RE: Inspection, County Canyon Mine, Ash Grove Cement, S/023/024, Juab, Utah

Date of Inspection: June 26, 1992

The purpose of this inspection was to evaluate the site of a new mine quarry and access road currently proposed by Ash Grove. The approximate location of the site is T12S, R2.5W, Sec. 25. The disturbance will include a quarry and about 3 miles of access road (see attached map).

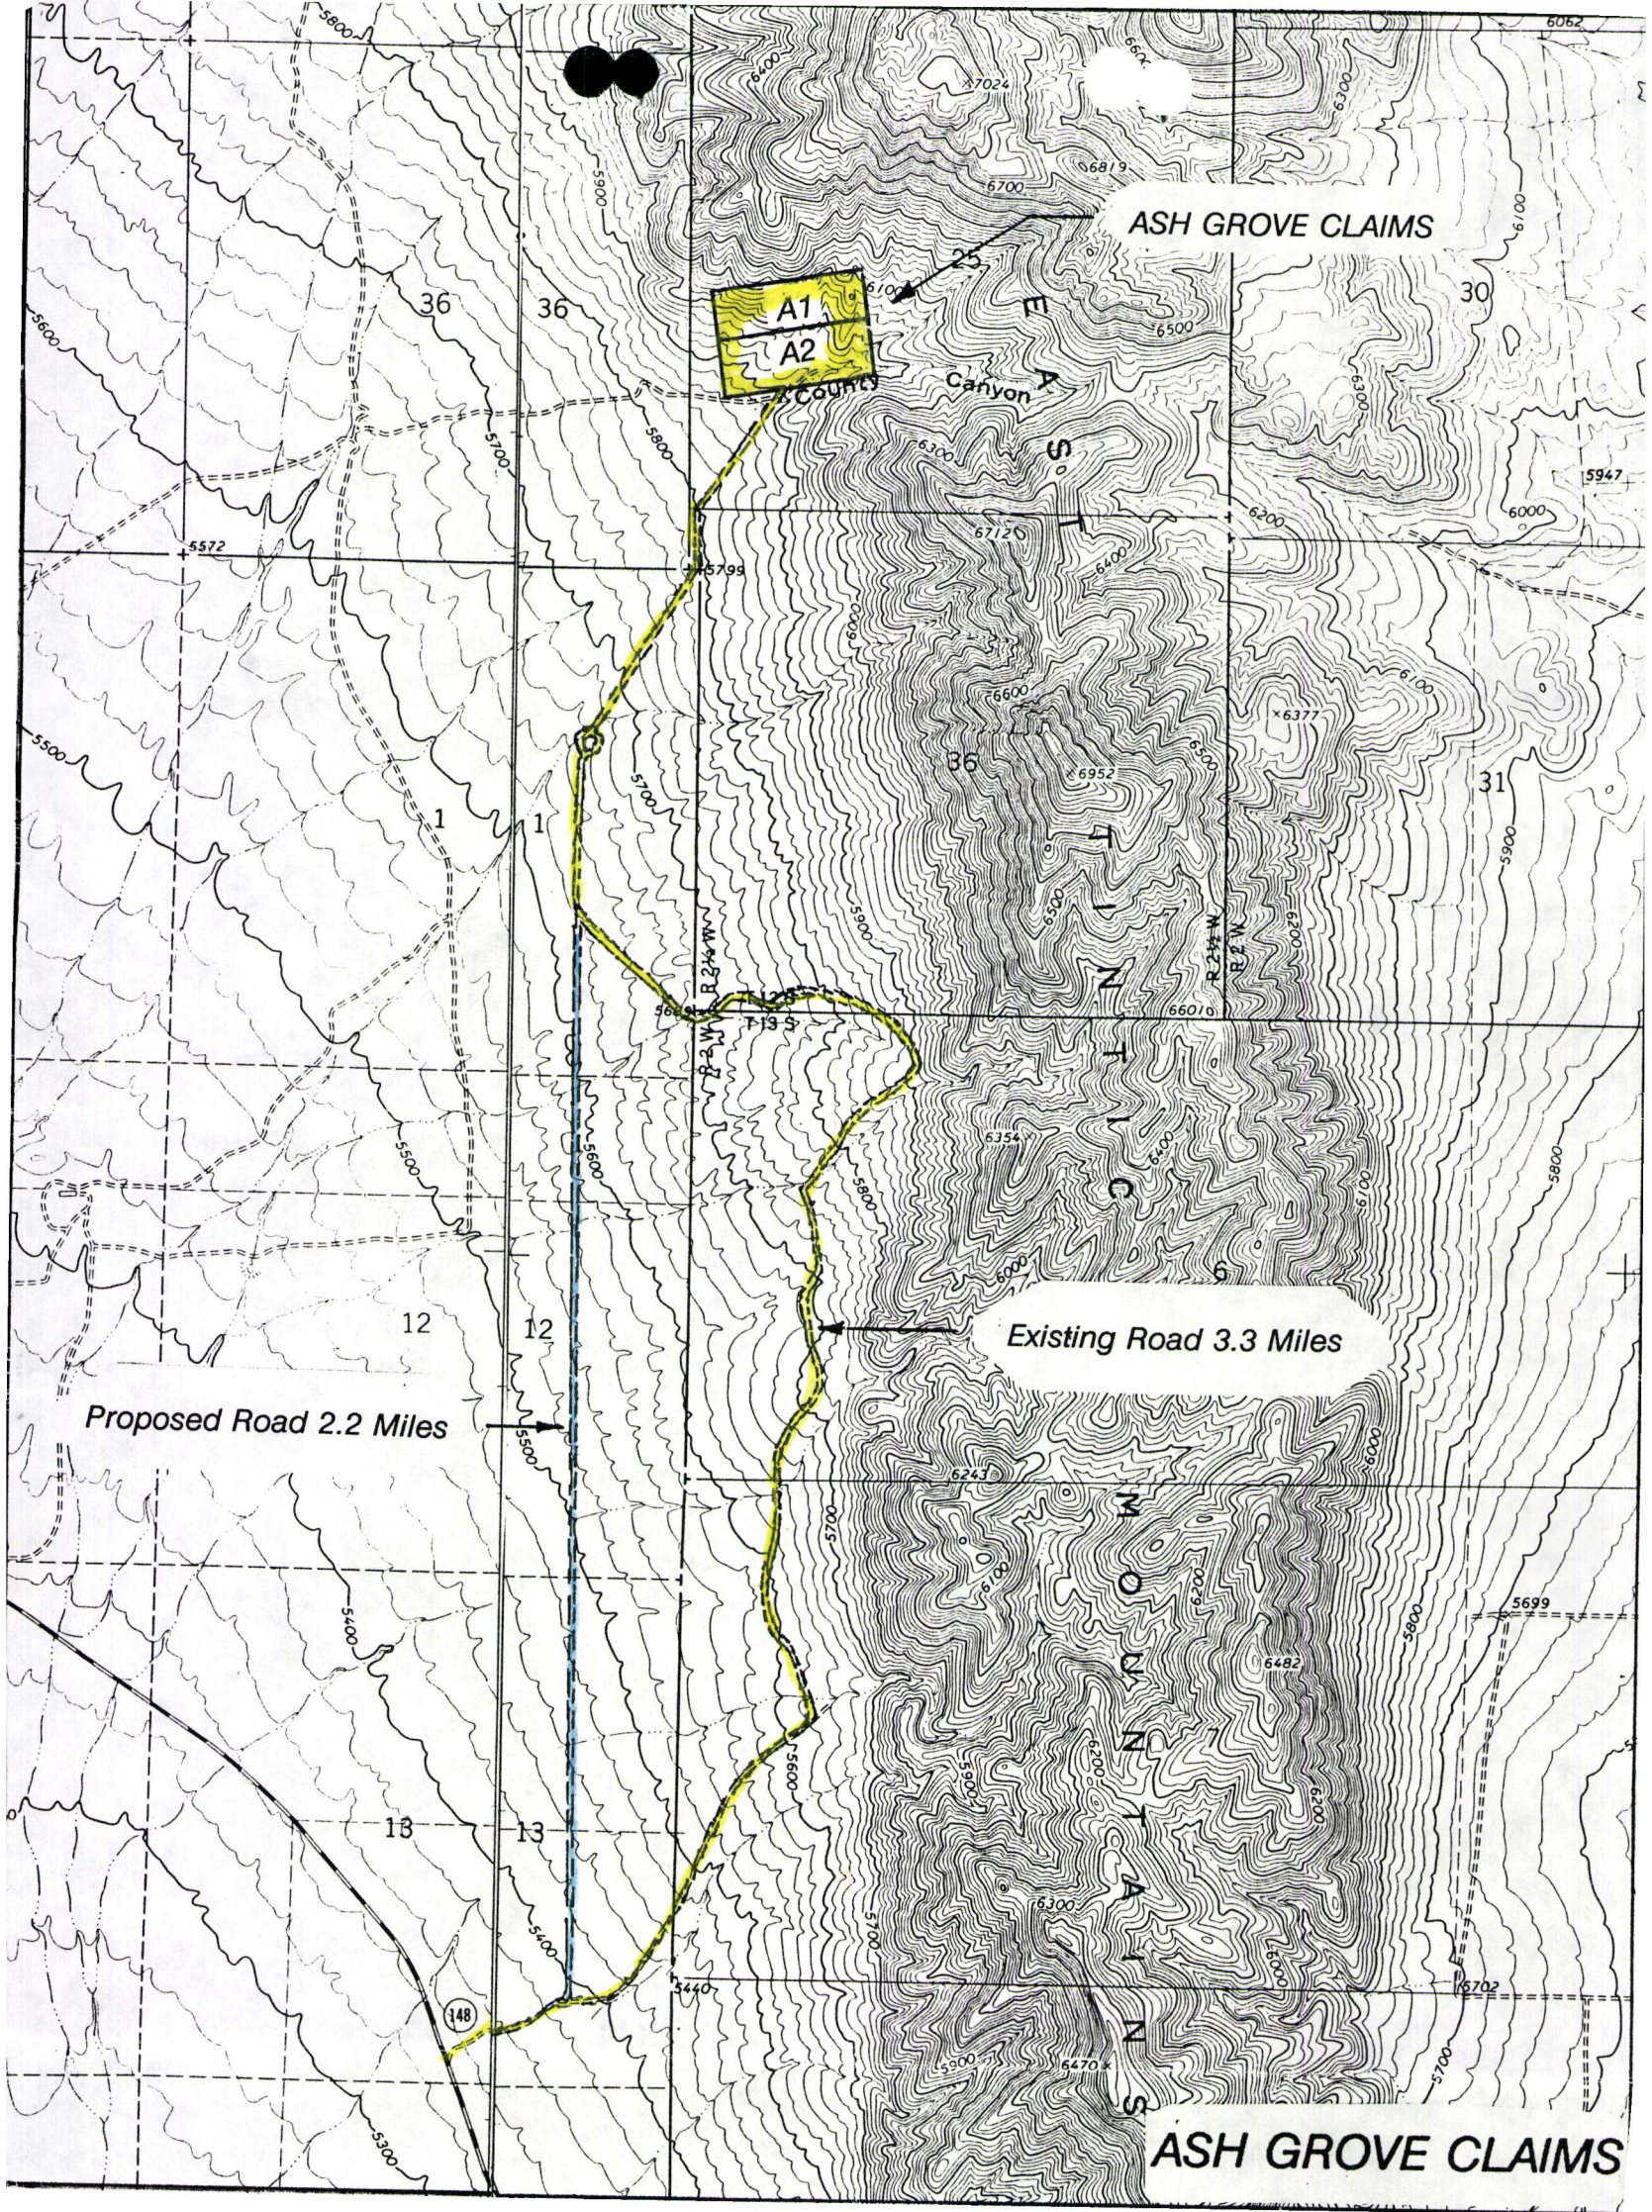
First portion of the inspection involved a look at the site of the quarry. The quarry has been initiated and currently disturbs @1/2 acre. The operator intends to disturb @6 to 8 acres before the project is complete. The quarry disturbance is entirely on BLM lands (see attachment).

The operator is proposing to construct a new road into the site that will be @2 miles in length and @20 feet wide. The road has not been initiated yet. The road is entirely on BLM land. The operator is currently using a county road to access his claims. The road ends at a turn around, then a new road has been constructed by the operator @3/4 of mile in length. It is @15 feet wide currently. A small portion of this road is on State property.

The operator needs to ensure that topsoil is being salvaged as mining proceeds at the quarry and along the road. Shrubs and trees can be scrapped up, along with topsoil for later application as soil and rough mulch. The soil and woody material salvaged should be place in a specific location and identified as a topsoil stockpile.

The operator needs to summit a Plan of Operations to the BLM addressing the disturbance and future reclamation of the site. The plan can be copied to the Division for our review. The plan should include the small portion of State property to be impacted by the road construction.
